**APPLICATION FOR
URBAN DESIGN COMMISSION
REVIEW AND APPROVAL**

PROJECT ADDRESS: 4802 Sheboygan Avenue

To: UDC
From: Brian Munson
CC: Al Martin
Tim Parks
Date: Monday, July 2, 2007
Re: Hill Farms Redevelopment: UDC Addendum

The following text and graphic amendments will be added to the General Development Plan submittal for the Hill Farms Redevelopment, in response to the initial approval discussions at the June 20th Urban Design Commission:

REVISED CONCEPT PLAN

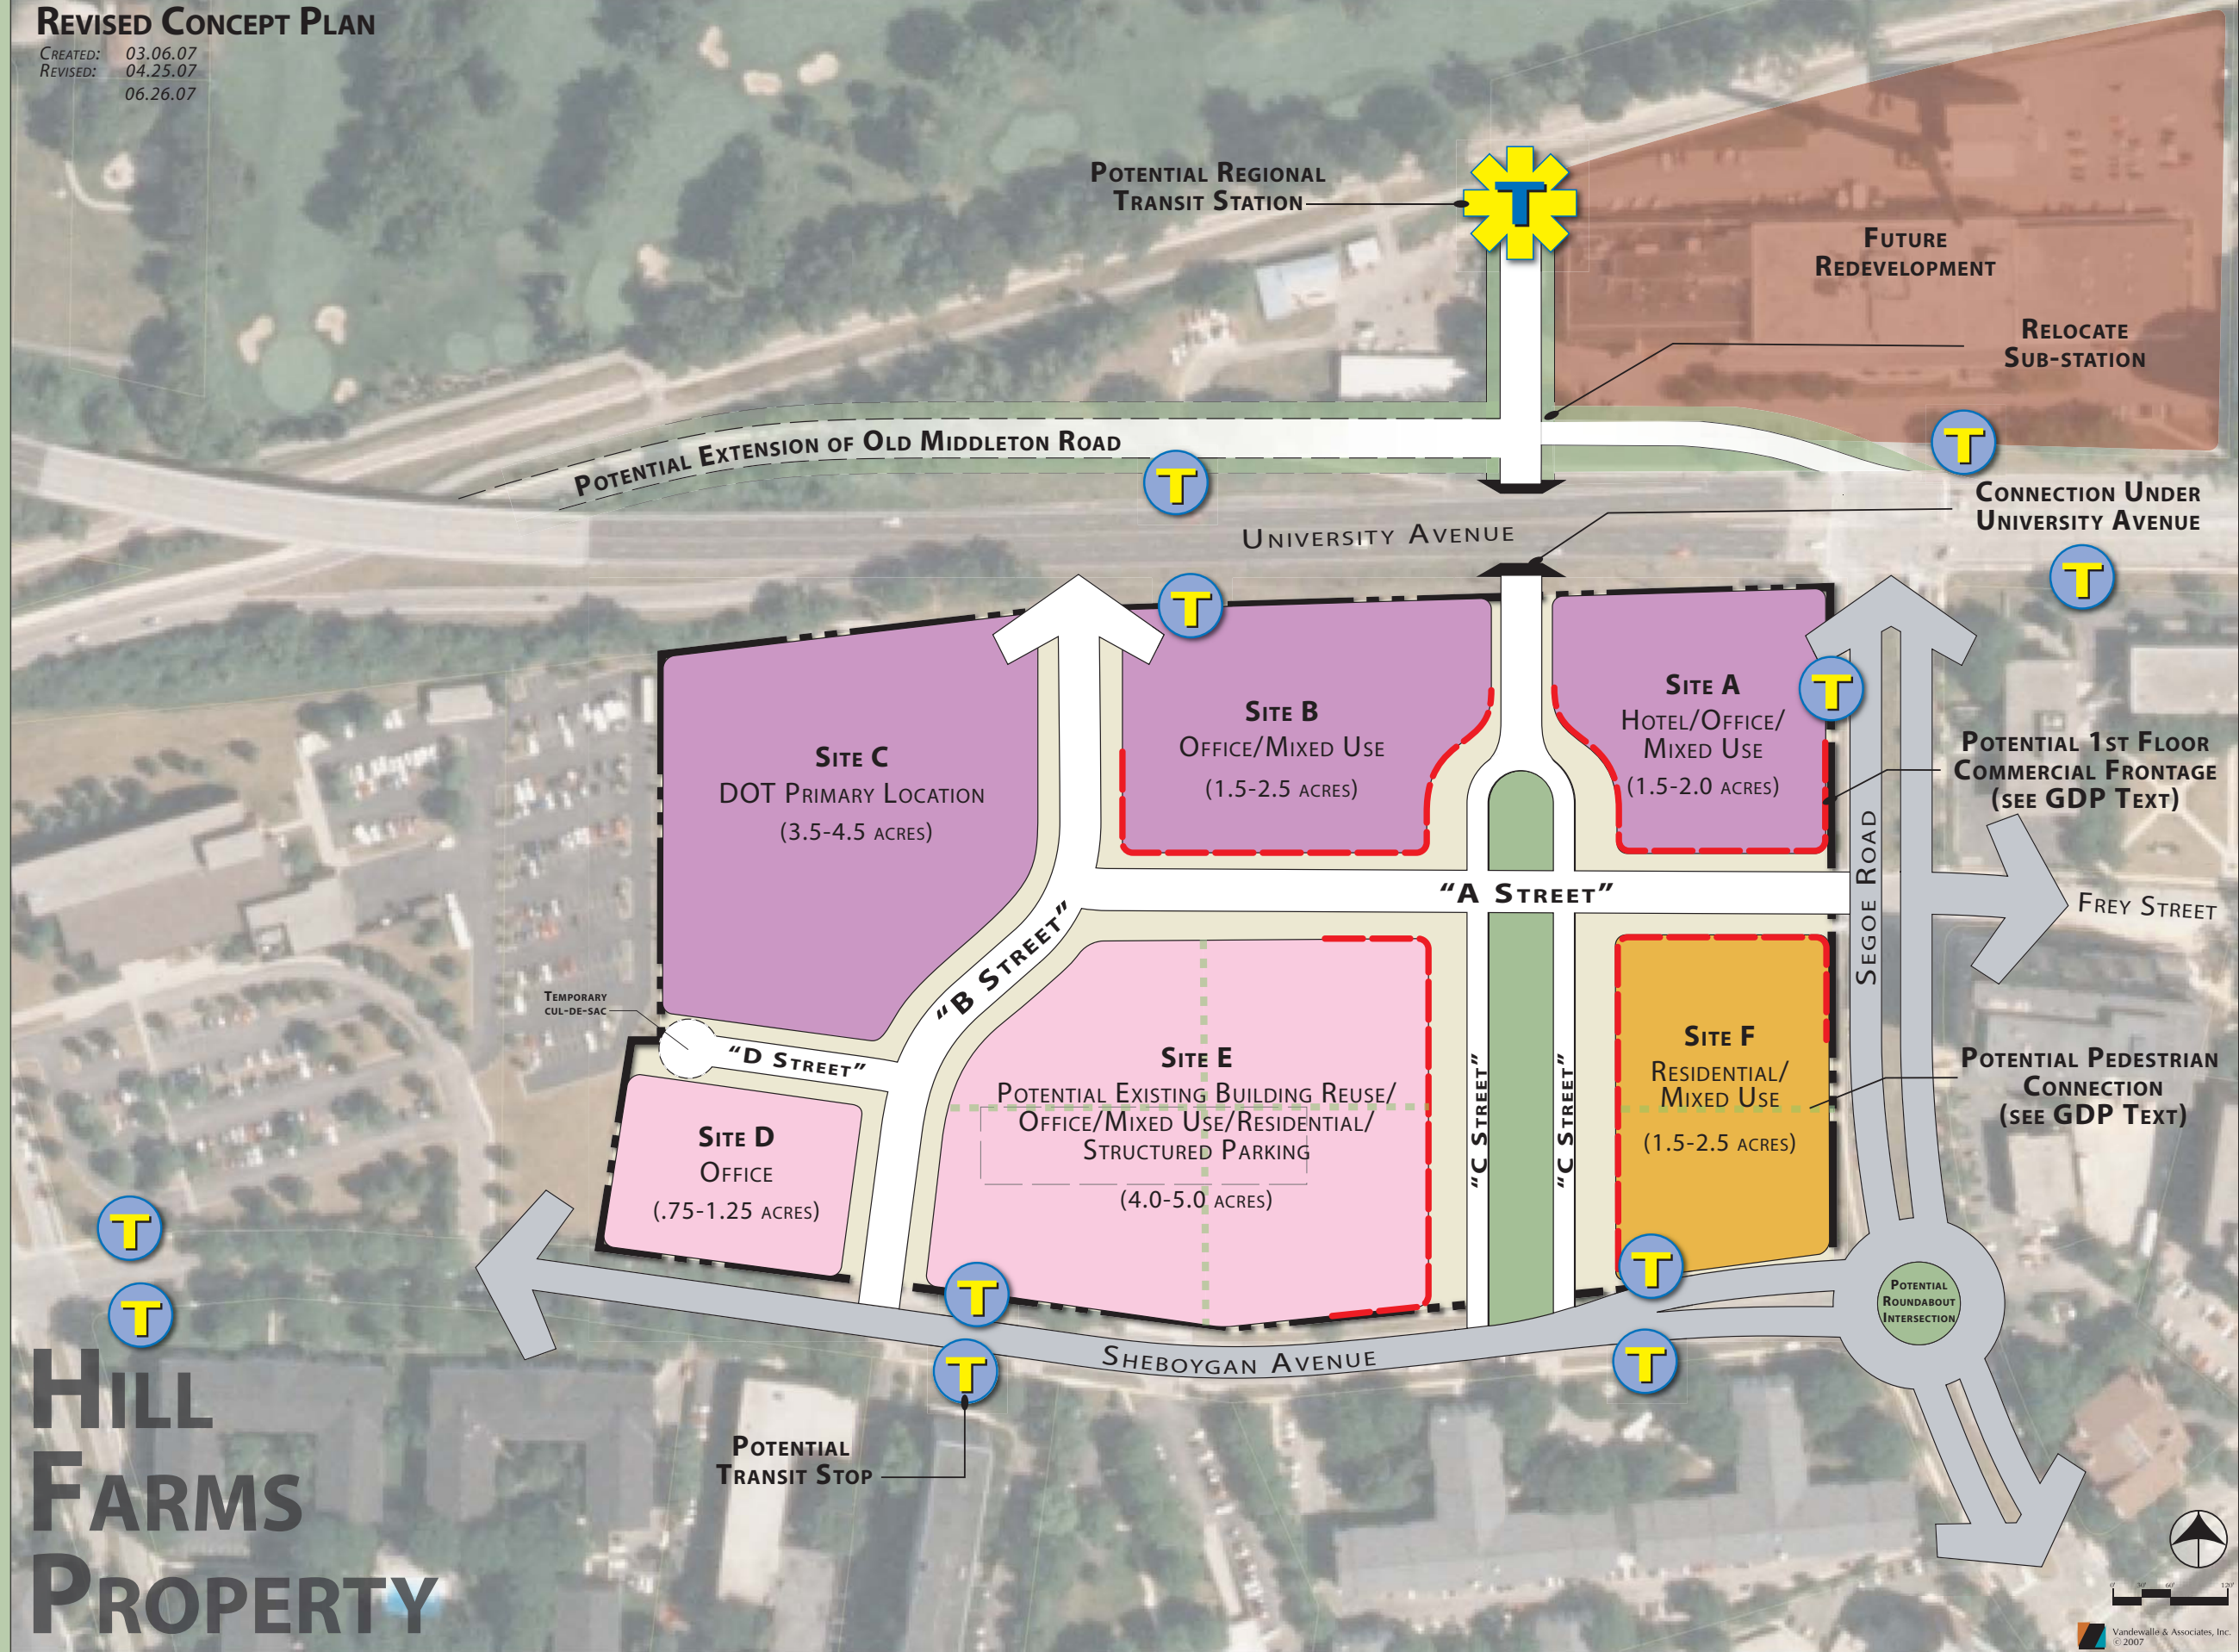
- 1.) Mid Block Connections
“Mid Block or interior circulation routes that accent the street pattern will be needed based on building layout, use locations, and open space provisions. The need for and placement of these connections shall be determined as part of the SIP and shall be specifically addressed as a component of the application.”

Note: The attached map includes conceptual locations and notation denoting the connections needed on Sites E & F.
